GISBORNE WASTEWATER NETWORK – OVERFLOW DISCHARGES: REGULATORY REF: DW-2020-109732-00/WD-2020-109733-00

Further S92 Response 21 April 2021

Attachment B: Flow Monitoring Records, June 2014

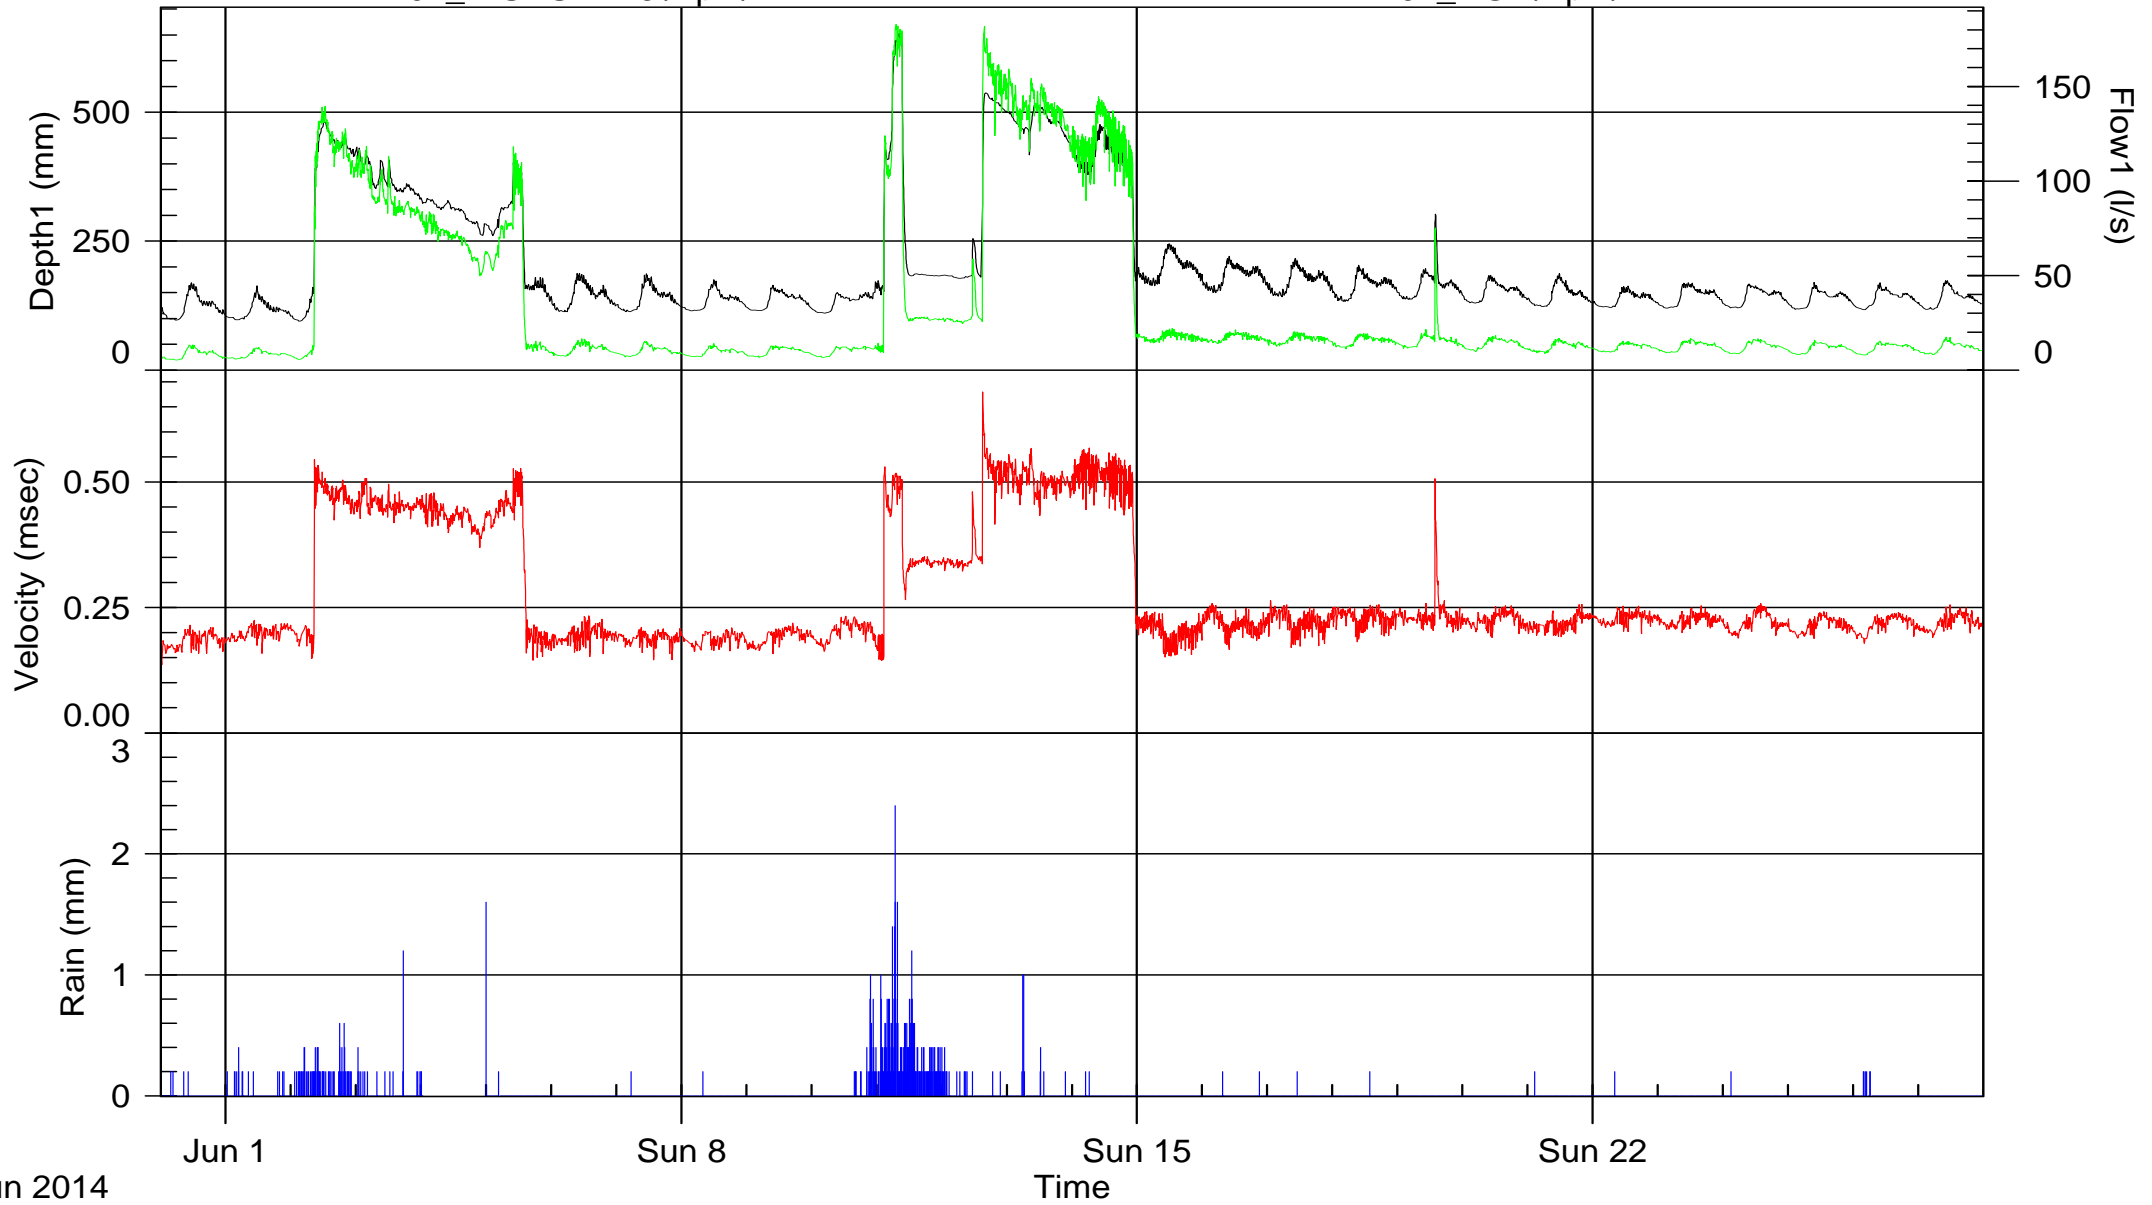
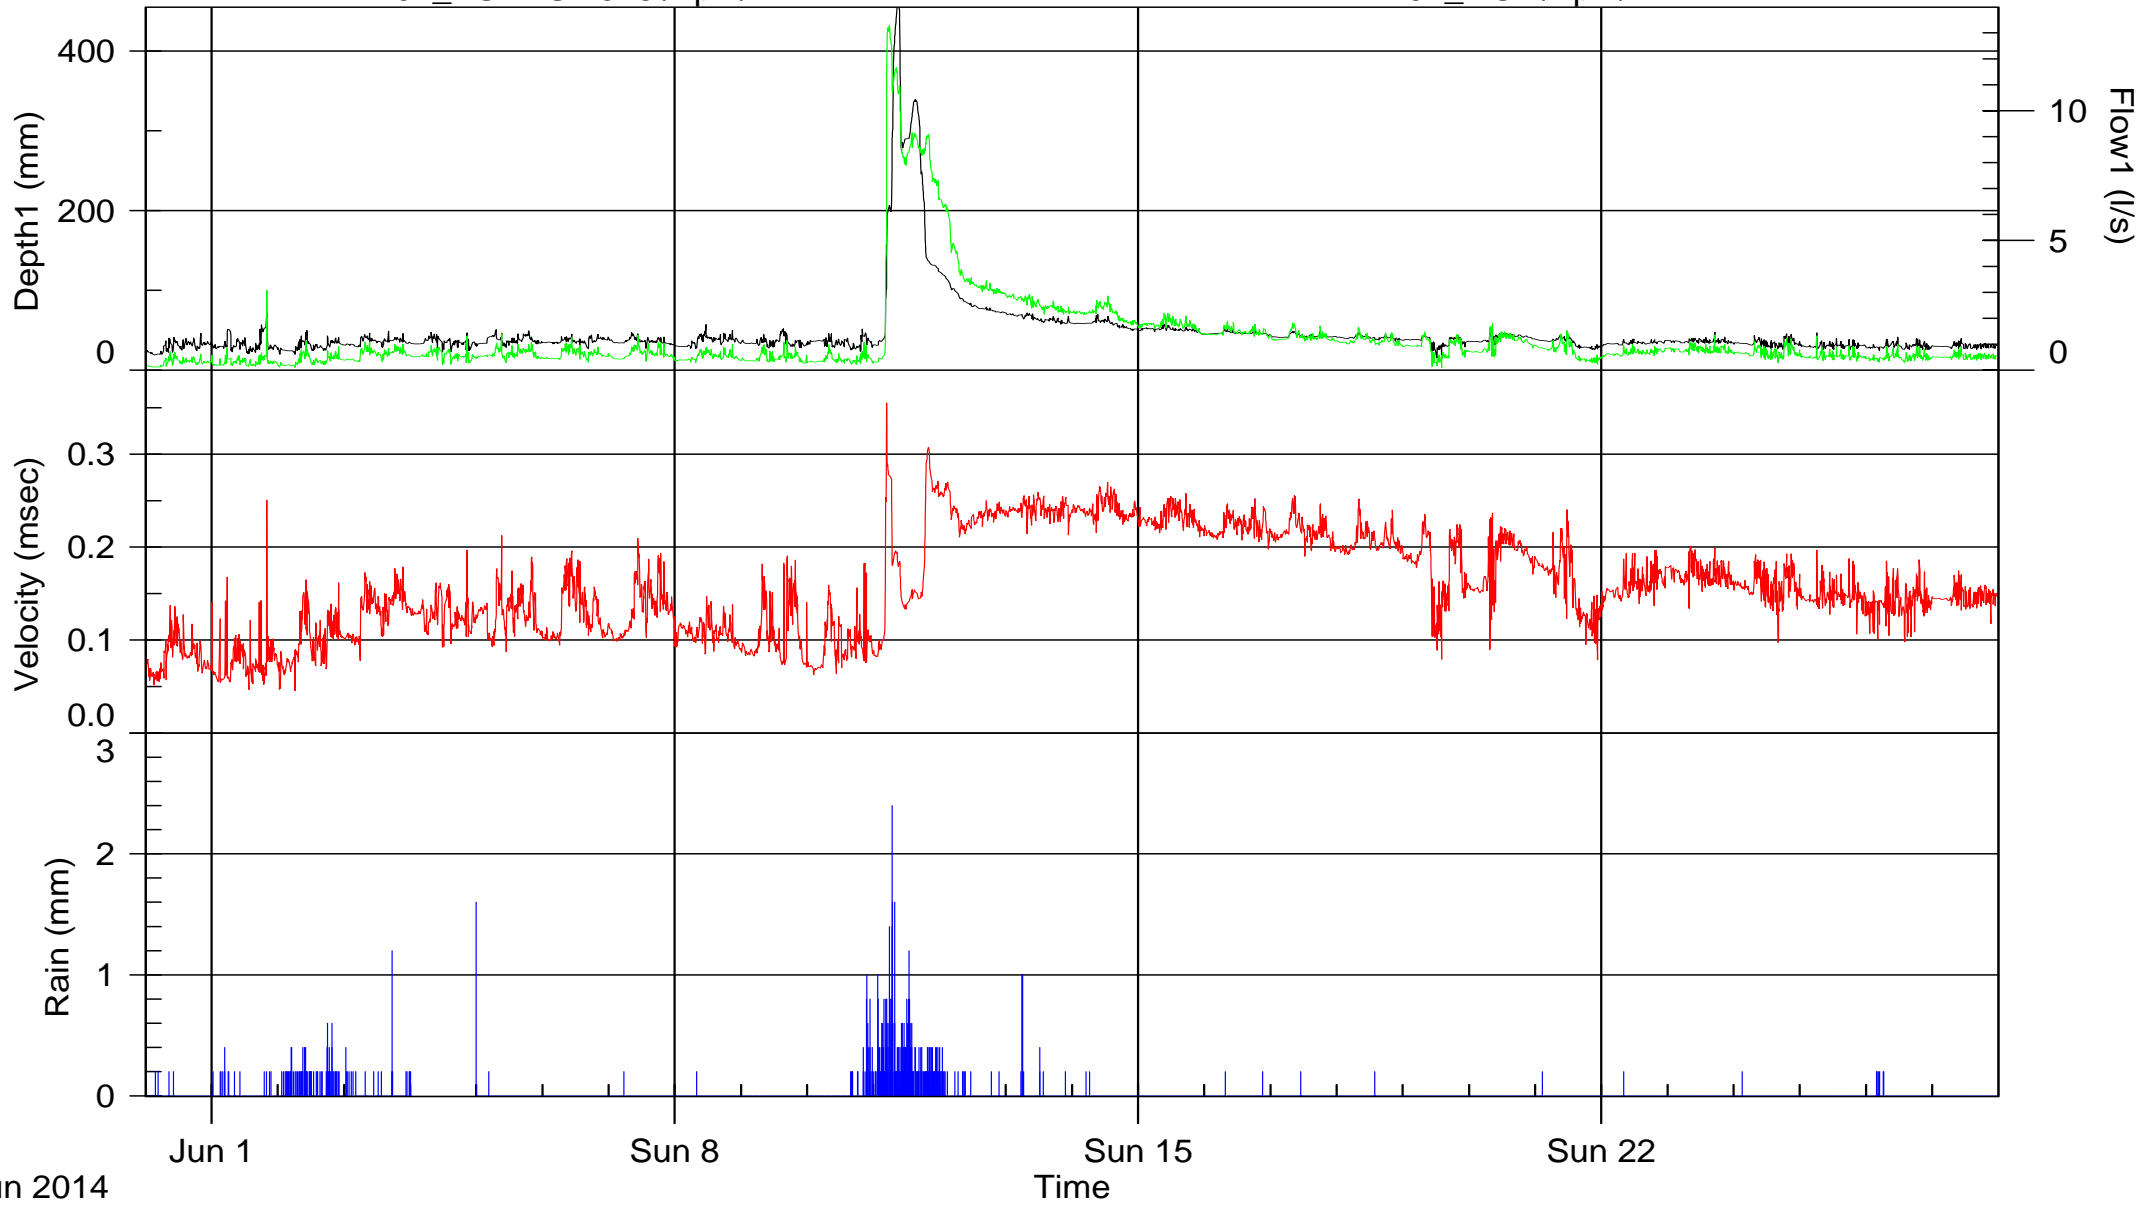
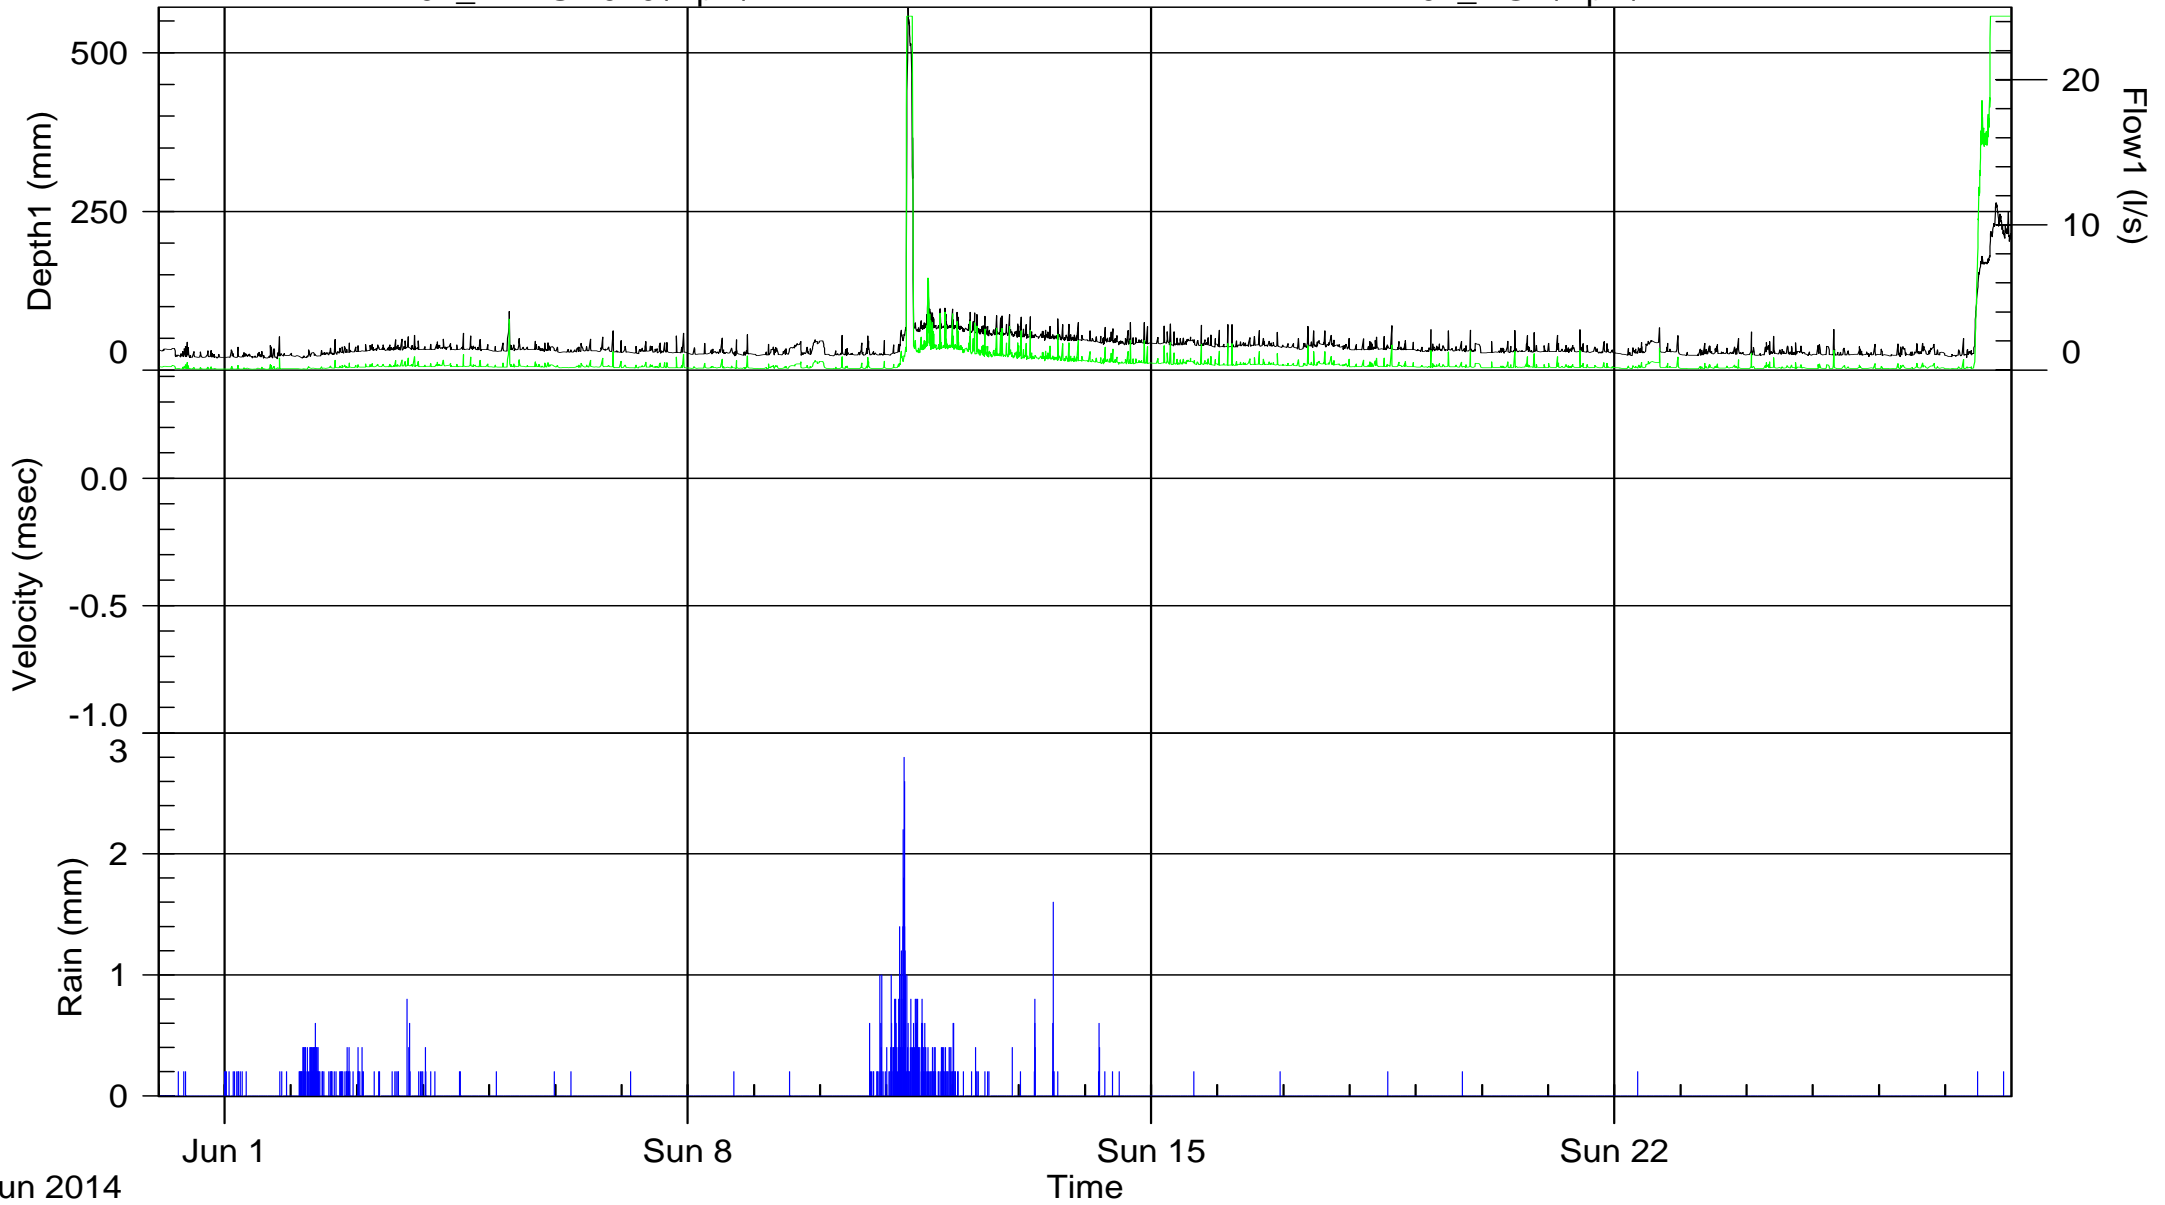
<p>upstream wastewater network including pump stations and reference (from the Mott Macdonald gauging report) which locations/hydrographs one(s) show the fast response to direct inflow?</p>	<p>We have also extracted flow monitoring information from the Mott Macdonald report for June 2014 (Attachment B) to facilitate review of the network flow monitoring across the monitoring sites. As can be seen from this extract, all of the monitoring sites show rapid response to heavy rainfall. Some sites to the south of the Taruheru River (eg APNISM135, DISRSM125 and LYTTSM075) also show the influence of overflow valves being opened from 11 to 12 June 2014.</p>
<p>b. Can the applicant provide a map/schematic that show areas of known property flooding referenced in the original application, page 223, see Figure 3-2 from the CH2M Beca Modelling Report, 2017. How does this compare to the nodes identified as flooding in the 2yr-ARI map (Figure B2) in the Beca modelling report.</p>	<p>A map showing indicative property ponding is provided below.</p> <p>The 'Ponding Likelihood' layer predicts where water is likely to pond on a property, based on a number of GIS layers that have been aggregated through a weighting process. These GIS layers include our stormwater flood model, depressions layer, and a Rain on Grid model.</p> <p>Ponding can be affected by many factors, e.g. fences on a property may divert flows, private stormwater sumps and pipes may drain areas, and soil conditions may allow for water to seep into the soil quicker than modelled. The data is also relevant to information available at a specific point in time, and things may have changed over time. Therefore, this layer is viewed as a guide only, as site conditions could be different.</p> <p>The modelled information is based on geospatial modelling, is for indicative purposes only. Council also uses records of actual flooding (surveys and Requests for Service received) and undertakes property inspections / investigations to validate whether or not there are actual effects, and whether or not stormwater drainage improvements (public or private) are required to mitigate the risk of ponding.</p> <p>The nodes identified in Figure B2 have been overlain on the Ponding Likelihood' layer. However, the location of property flooding in heavy rainfall will not necessarily correlate to the location of wastewater overflows from manholes.</p> <p>While property flooding is considered a primary cause of rainwater entering the wastewater system, properties that experience wastewater overflows will not necessarily also be the properties that experience rainwater flooding. Property</p>

<p>c. Can the applicant please provide a <u>model calibration report</u>. This should include a comparison between predicted/modelled flows and gauged data and demonstrate how well the model performs. This is required to determine the level of confidence in the modelling results (and subsequent conclusions).</p>	<p>No specific calibration report was produced. The flow gauge data and model graphs were part of the calibration process as is standard practice. The model aims to reflect the AWT flow gauging report that shows rainfall and the resultant wastewater flows that occur very quickly afterwards. As indicated in our previous response, the flow gauging sites were selected with a key aim of calibrating the model to predict overflow performance. The flow records show rapid and substantial increases in wastewater network flows associated with rainfall events and this is a clear demonstration of the result of direct stormwater inflow (Fast Response), which is replicated in the wastewater model.</p>
